Re: Site Plan Review, ALE Addition, Bryant School District, Bryant, AR

Below is our response to the DRC comments:

BRYANT ALE CLASSROOM ADDITION
BRYANT PUBLIC SCHOOLS
BRYANT, ARKANSAS

1 SITE PLAN
A9.0 1" = 30'-0"

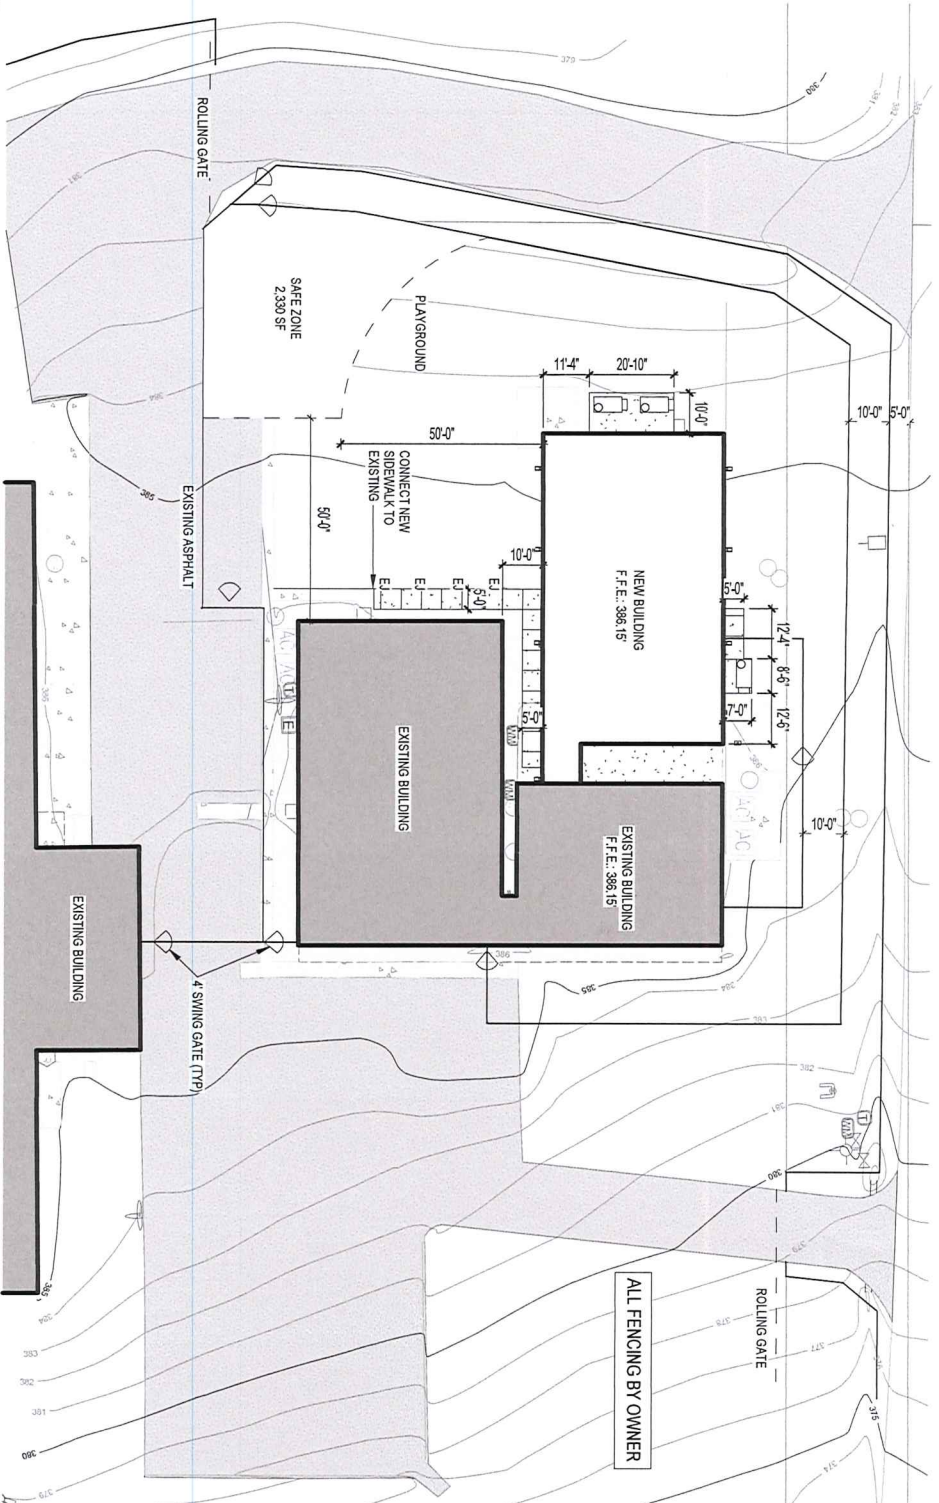
3. See attached Site Plan for fencing limits.
4. Handicap accessibility will come from the connection to the existing building.

1. See attached Site Plan for fencing limits and Safe Zone requirements.
2. The Safe Room occupant load capacity is 305 based on the square footage.
